# HALLIBURTON
## LOGGING TECH BUILDING
GRAND JUNCTION, COLORADO
3199 D RCAD

# A1.1A

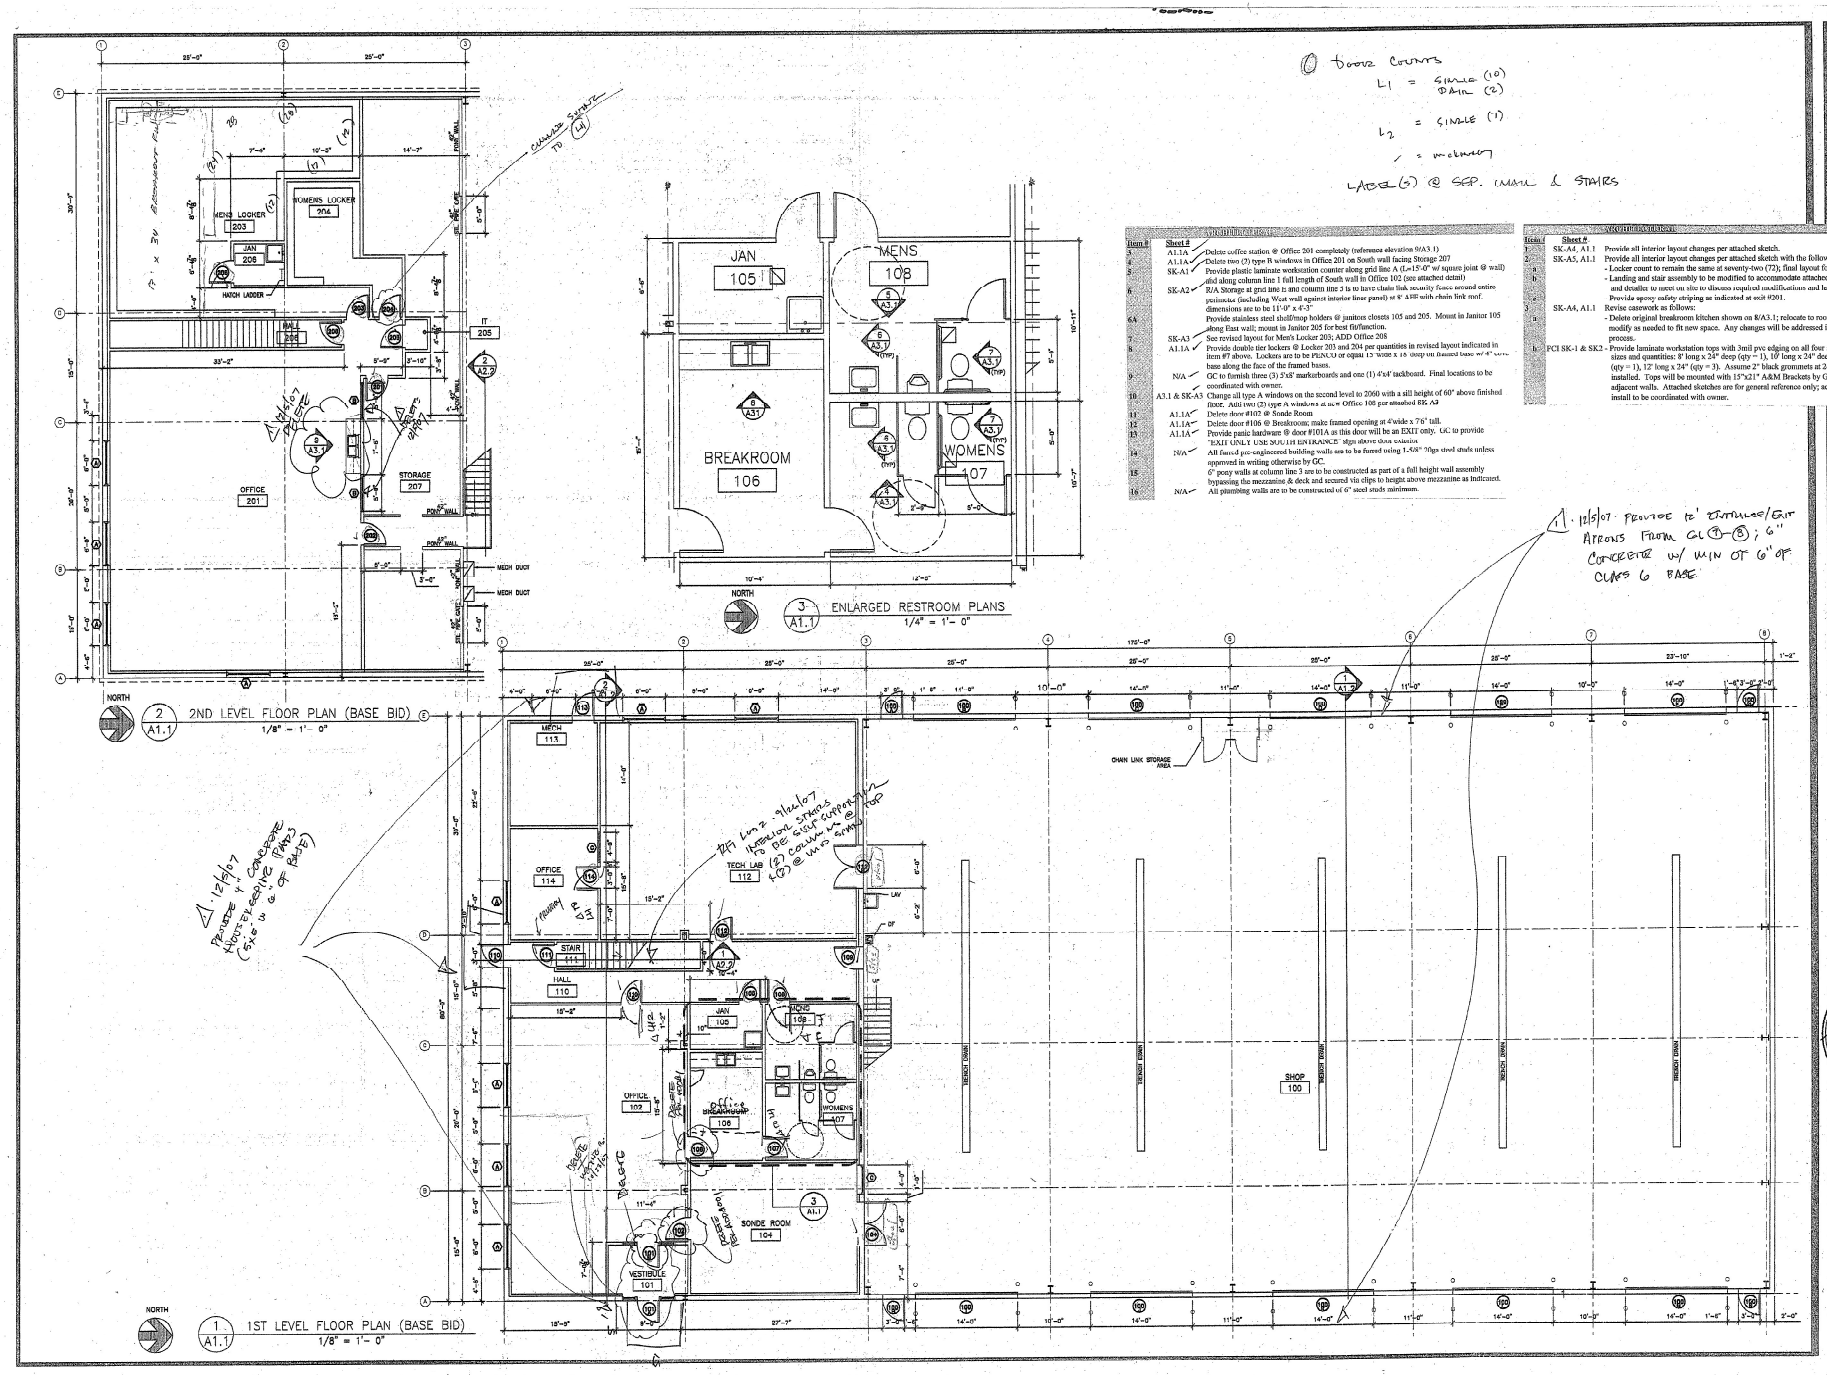
| Item # | Sheet # | Description |
|---|---|---|
| 5 | A1.1A | Delete coffee station @ Office 201 completely (reference elevation 9/A3.1) |
| 4 | A1.1A | Delete two (2) type B windows in Office 201 on South wall facing Storage 207 |
| 8 | A1.1A | Provide double tier lockers @ Locker 203 and 204 per quantities in revised layout indicated in item #7 above. Lockers are to be PENCO or equal 15 wide x 18 deep on floated base w/ 4" [illegible] base along the face of the framed bases. |
| 11 | A1.1A | Delete door #107 @ Sonde Room |
| 12 | A1.1A | Delete door #106 @ Breakroom; make framed opening at 4'wide x 7'6" tall. |
| 13 | A1.1A | Provide panic hardware @ door #101A as this door will be an EXIT only. GC to provide 'EXIT ONLY USE DOUBLE ENTRANCE' sign above door exterior |

1 · 12/5/07 · PROVIDE 12' EXTERIOR/EXIT APRONS FROM GL 1–8; 6" CONCRETE W/ MIN OF 6" OF CLASS 6 BASE

1 · 12/6/07 PROVIDE 4" CONCRETE HOUSEKEEPING PADS (FITS IN 6" OF BASE)

RFI #002 · 12/6/07 INTERIOR STRUTS TO BE SELF SUPPORTING (2) COLUMN LINE @ THIS WALL TOO
